CITY OF CODY PLANNING, ZONING AND ADJUSTMENT BOARD TUESDAY AUGUST 24, 2021 CITY HALL COUNCIL CHAMBERS @ 12:00 NOON

CITY OF CODY PLANNING, ZONING AND ADJUSTMENT BOARD STAFF REPORT				
MEETING DATE:	AUGUST 24, 2021	TYPE OF ACTION NEEDED		
AGENDA ITEM:		P&Z BOARD APPROVAL:		
SUBJECT:	PRELIMINARY PLAT FOR MIKEL & RETHA PEDERSON, A 2-LOT MINOR SUBDIVISION. SUB 2021-05	RECOMMENDATION TO COUNCIL:	Х	
PREPARED BY:	TODD STOWELL, CITY PLANNER	DISCUSSION ONLY:

CITY OF CODY PLANNING, ZONING AND ADJUSTMENT BOARD STAFF REPORT **MEETING DATE:** AUGUST 24, 2021 TYPE OF ACTION NEEDED AGENDA ITEM: P&Z BOARD APPROVAL: Χ **SUBJECT: UPDATED DESIGN FOR** RECOMMENDATION TO CONDITIONAL USE REQUEST: MODULAR COUNCIL: Accessory Dwelling Unit in R-2 ZONE, 2442 CENTRAL AVENUE. SUP 2021-10 PREPARED BY: TODD STOWELL, CITY PLANNER **DISCUSSION ONLY:**

CITY OF CODY PLANNING, ZONING AND ADJUSTMENT BOARD STAFF REPORT				
MEETING DATE:	August 10, 2021	TYPE OF ACTION NEEDED		
AGENDA ITEM:		P&Z Board Approval:	Χ	
SUBJECT:	CONDITIONAL USE REQUEST: MODULAR ACCESSORY DWELLING UNIT IN R-2 ZONE, 2442 CENTRAL AVENUE. SUP 2021-10	RECOMMENDATION TO COUNCIL:		
PREPARED BY:	TODD STOWELL, CITY PLANNER	DISCUSSION ONLY:

In concept, the pathway would be as shown on the rural road standard, shown below.

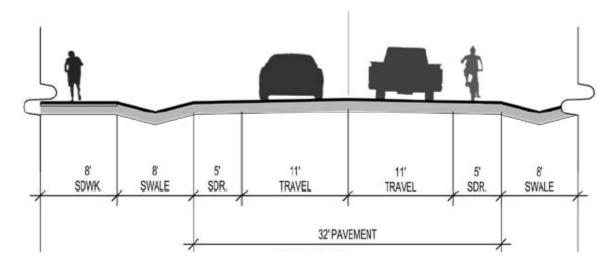
Comment: A waiver of curb, gutter and sidewalks along Robert Street is requested. However, on recent subdivisions on 29th Street, and at the corner of Robert Street and Kent Avenue, the City has required an asphalt pathway as an alternative that meets the intent of the sidewalk requirement and can occur without curb and gutter being in place. The Board can discuss the situation and determine if the pathway option should be required along the Robert Street frontage of this subdivision. There is room for it to fit between the property line and the power poles. A pathway/pedestrian route is shown along Robert Street on the master plan trails map.

- 1. (If a pathway is recommended, include the following condition: The applicant shall have a minimum 8-foot-wide pathway designed and installed along the Robert Street frontage of the property. The plans must be approved by Public Works and installation must meet City standards. Installation must occur prior to a building permit being issued for Lot 16B, or any additional development of Lot 16A, whichever occurs first. If the work is not done before the final plat is recorded, include a note on the final plat about the outstanding requirement.
- 2. The final plat application will need to address the surface water (irrigation) rights on the property. The options are either to transfer the water rights to another property in the Cody Canal irrigation district, or to develop a distribution plan to

PRELIMINARY PLAT OF PEDERSON MINOR SUBDIVISION

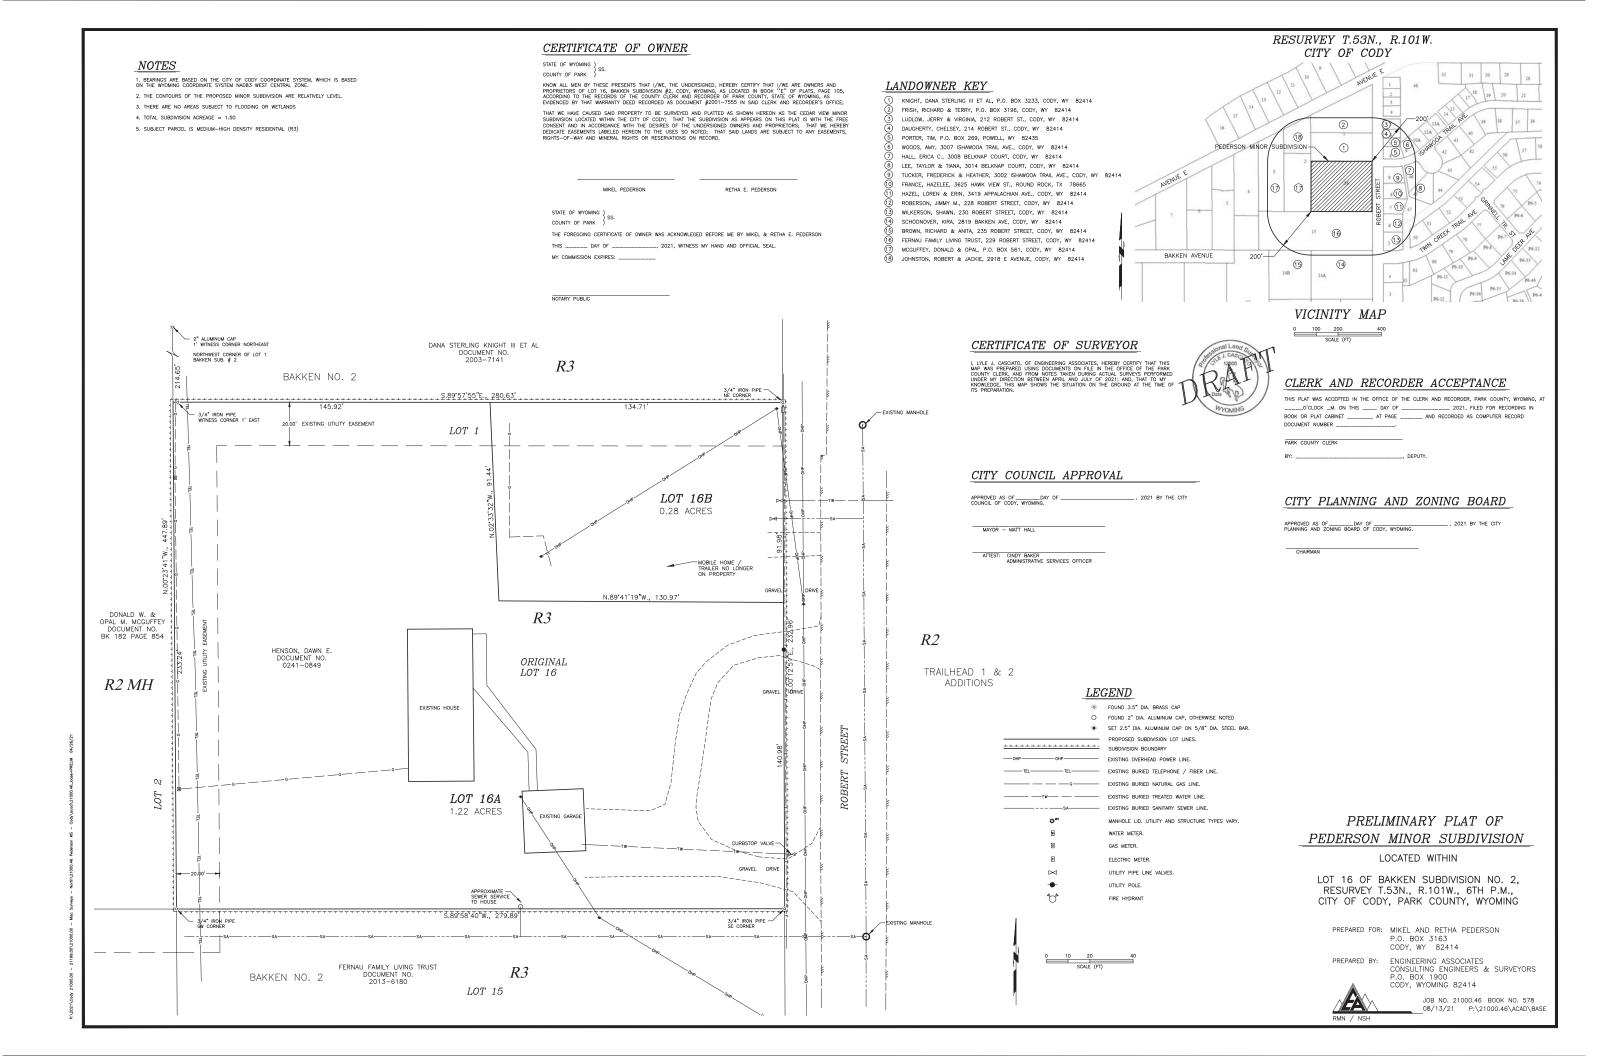
Comment- No new public streets or alleys are proposed.

Comments- No interior streets through this property are identified in the master street plan. Robert Street has 60 feet of right-of-way, but it is classified as a major collector. As a major collector, it would ideally have 80 feet of right-of-way, but due to existing development, the City recognizes that future improvement to Robert Street will be limited to the existing 60-foot width of right-of-way.

Comment: A variance to the alley requirement is requested. There are no adjacent alleys to tie into.

Comment: Both lots have existing 4" sewer service lines.

Comment: There is a small irrigation ditch that runs along the east side of the property. The applicant will need to contact the irrigation company to coordinate the piping of the ditch. If for some reason the irrigation company does not want the ditch piped, submit that information with the final plat application for consideration.

Comment: All basic utilities are in place to both lots. When Lot 16B is developed, power will need to come from down the pole at its northeast corner and run underground to the new house. The existing overhead service line would be removed.

Comment: There is no street light system on Robert Street. A variance to the street lighting requirement is proposed.

- 1. Variance to the alley requirement.
- 2. Variance to not dedicate any additional right-of-way for Robert Street.
- 3. Variance to the streetlighting requirement.
- 4. Variance to the block length requirement.
- 5. (If a pathway along Robert Street is not required, grant a waiver of curb, gutter and sidewalk improvements, subject to a commitment to participate in any future improvement district project to do so.)

- utilize those water rights. Contact Cody Canal for approval of the irrigation distribution plan, or to give their permission for the State Engineer's Office to consider a transfer of the water rights.
- 3. Coordinate the piping of the irrigation ditch with the ditch company. Complete the piping prior to a building permit being issued for Lot 16B, or any additional development of Lot 16A, whichever occurs first. If the work is not done before the final plat is recorded, include a note on the final plat about the outstanding requirement.
- 4. All work within the Robert Street right-of-way requires an encroachment permit from Public Works, prior to excavation or construction. It is the contractor's responsibility to obtain the permit.

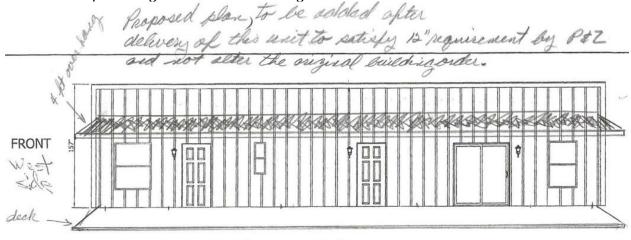
The applicants have submitted the drawing shown below as their plan to meet the condition of providing an eave and awning on the modular home.

Plus 4x4 or 6x6 posts as recoled

If the proposed architecture is acceptable to the Board, authorize the plan shown and identify a timeline for when the awning/roof must be installed. (One year from when the modular home is occupied?)

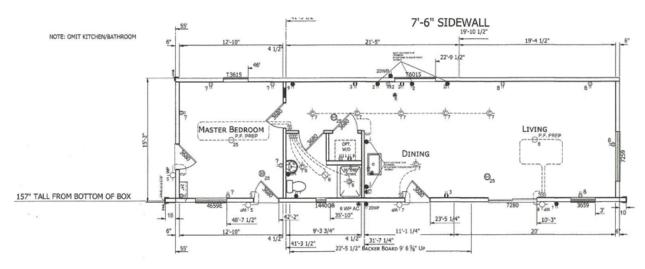
The architecture of the propose ADU is modern, but simpler than what staff would prefer. In effect, there are no architectural enhancements. Note that the rendering on the first page shows a pergola and deck, but those are not proposed on this project. As this is the first modern ADU in the neighborhood, it is desired that it clearly establishes a suitable precedent.

In reviewing the architecture of the home, it is noted that the design does not comply with the eave requirement of the residential supplemental development standards, which requirement is that, "Eaves

shall extend at least twelve inches (12") from the building." A roof modification to add eaves to the three sides that are missing would add a reasonable level of architectural variety. Other options could include decorative metal awnings or variations in siding texture, color or materials. Some examples of these concepts are shown below.

- 1) Provide architectural enhancement(s) as determined by discussion between the applicants and the Board. (Add roof eaves? And/or other enhancements?)
- 2) A building permit for the ADU must be obtained within 2 years or the authorization shall automatically expire.
